Submit comment on Draft 2021-2022 Transmission Plan

2021-2022 Transmission planning process

The Bay Area Municipal Transmission group (BAMx)¹ appreciates the opportunity to comment on the Draft 2021-2022 Transmission Plan (Draft Plan, hereafter), dated January 31, 2022. The comments and questions below also address the material presented at the CAISO Stakeholder meeting on Feb 7, 2022. BAMx acknowledges the significant effort of the CAISO staff to develop the Draft Plan. BAMx recognizes the tremendous amount of work the CAISO staff has completed in this planning cycle. BAMx also believes the CAISO staff must be allowed a corresponding amount of time to engage the stakeholders to explain the staff's work.

Cortina 230/115/60 kV Bank #1 Replacement

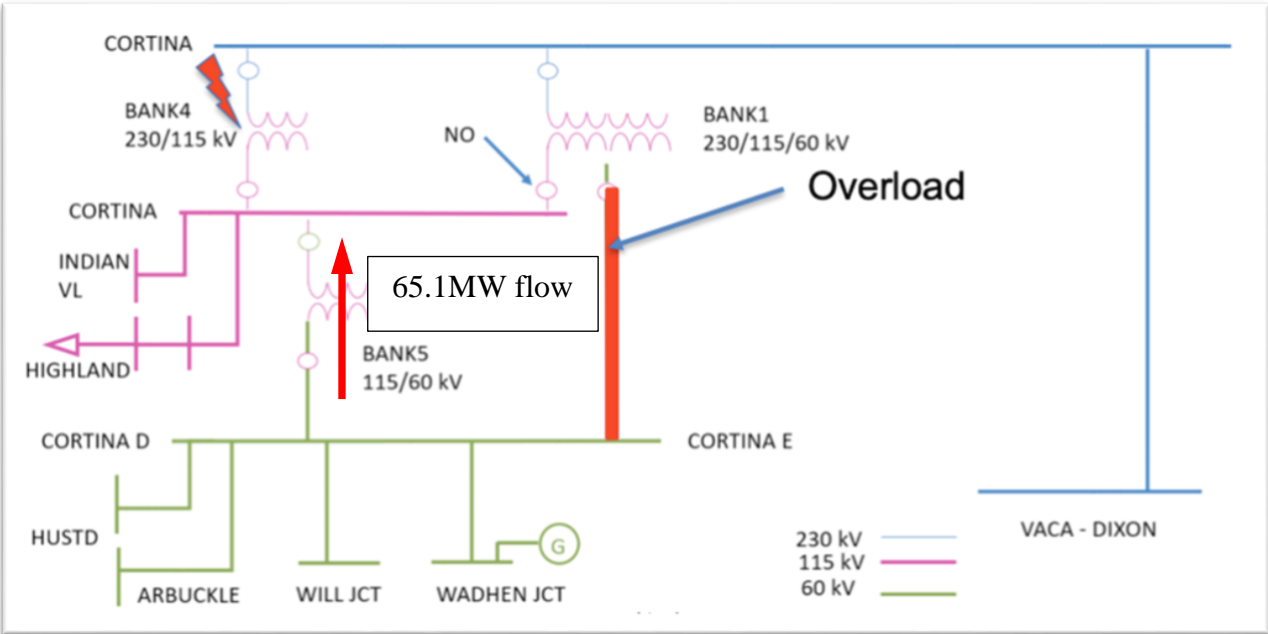
Cortina 230/115/60kV Bank #1 was identified to be overloaded for a P1 loss of Cortina 230/115kV Bank #4 and a P3 contingency for the loss of the same Cortina 230/115kV Bank #4 and Wadham Generator #1. The total load served radially by the Cortina 60kV substation is approximately 73.6MW. The emergency rating of Cortina 230/115/60kV transformer bank is 84MVA, and the bank can reliably support all the load even with the Wadham units off-line. The overloads identified by PG&E are due to impedance imbalance causing a flow of approximately 65.1MW from Cortina 60kV to Cortina 115kV substation through the 115kV/60kV transformer as identified on diagram below.

The identified overloads on Cortina 230/115/60kV #1 bank can be avoided by keeping either Cortina 230/115/60kV #1 bank or Cortina 115/60kV bank normally open. This configuration will avoid replacing Cortina 230/115/60kV #1 bank, and Cortina 60kV substation will still be reliably served since the transformer kept normally open could be utilized to restore Cortina load in case of failure of the primary transformer. Therefore, BAMx recommends against approving the *Cortina 230/115/60 kV Bank #1 Replacement Project* at this time.

Transmission Capital Expenditures and HV TAC Projections: 2023-2031

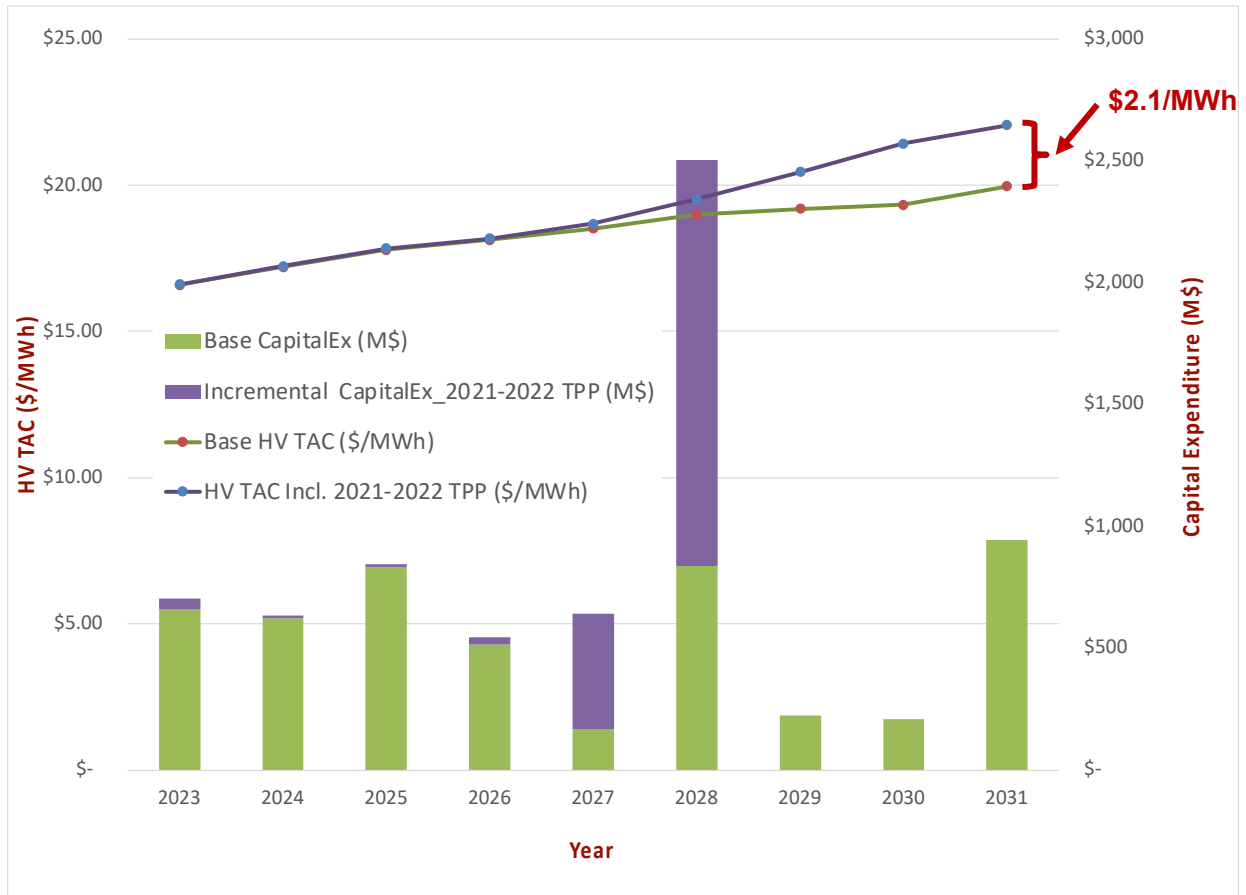
As shown in the figure above, the HV TAC is expected to be more than \$22/MWh in 2031 relative to the existing \$16.60/MWh, a 33% increase in less than a 10-year timeframe. Out of the \$22/MWh HV TAC in 2031, more than \$2/MWh is solely attributed to the nearly \$3 billion transmission projects³³ the CAISO has recommended for approval in the current TPP cycle. These HV TAC projections show the tremendous impact these approvals will have on the ever-increasing CAISO-wide HV TAC and further justify the need to avoid approving excessive transmission projects without further review and analysis.
